# Access Compliance Report

## Public Rights-of-Way

Intersection ID: 2711	Main Street: FAIRWAY_POINT_DR	Cross Street: HIGHLAND_CREEK_PY	Location: SW
ADA ID: 5A05042CC97A	Ramp Type: PerpDiag	Initial Pass/Fail: Fail	Overall Compliance: No
Severity Score: 37.5			
Codes/Mitigation Info/Possible Solution		Field Measurements/Component Compliance

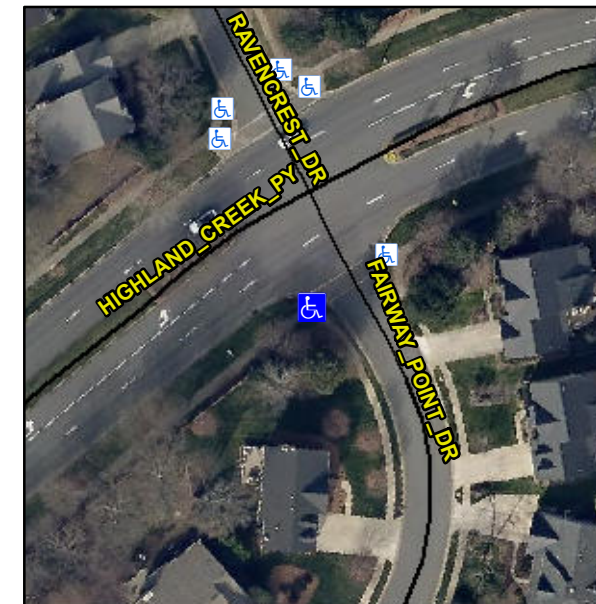
**R304.2.2, R304.5.3**

Compliance	Description	Data	Compliance	Description	Data
N/A	Ramp Length (in)	53.0	No	Ramp Slope (%)	11.5
Yes	Ramp Width (in)	48.0	No	Ramp XSlope (%)	13.7
N/A	Flare Type LT	N/A	N/A	Flare Type RT	N/A
N/A	Flare Slope LT (%)	N/A	N/A	Flare Slope RT (%)	N/A
N/A	Flare Traversable LT?	N/A	N/A	Flare Traversable RT?	N/A
N/A	Landing Length (in)	N/A	N/A	DWS Provided?	N/A
N/A	Landing Width (in)	N/A	N/A	DWS Contrast?	N/A
N/A	Landing Slope (%)	N/A	N/A	DWS Length (in)	N/A
N/A	Landing X Slope (%)	N/A	N/A	DWS Full Width?	N/A
N/A	Landing Curb? (Y/N)	N/A	N/A	DWS Offset (in)	N/A
N/A	Shared Landing?	N/A			
N/A	Gutter Ponding?	N/A	N/A	Gutter Slope (%)	N/A
N/A	Gutter Lip Ht (in)	N/A	N/A	Gutter X Slope (%)	N/A
N/A	Painted X Walk1?	No	N/A	Painted X Walk2?	No
	X Walk 1 Direction	To E		X Walk 2 Direction	To N
N/A	X Walk 1 Width (in)	N/A	N/A	X Walk 2 Width (in)	N/A
	X Walk 1 Slope (%)	8.3		X Walk 2 Slope (%)	4.6
	X Walk 1 X Slope (%)	3.8		X Walk 2 X Slope (%)	6.6

N/A	Ramp inside XWalk1?	N/A	N/A	Ramp inside XWalk2?	N/A
	Road Slope (%)	11.3	N/A	Clear Space?	N/A
	Road X Slope (%)	3.5	N/A	Clear Space to XWalk (in)	N/A
N/A	Any Obstructions?	N/A	N/A	Storm Grate/Utility Hazard?	N/A
	Obstruction Type			Storm Grate/Utility Type	
		N/A			N/A
		Yes		Surface Condition? (G/P)	Good

**Remove & Replace Curb Ramp With Two New Directional Ramps or Equivalent.**
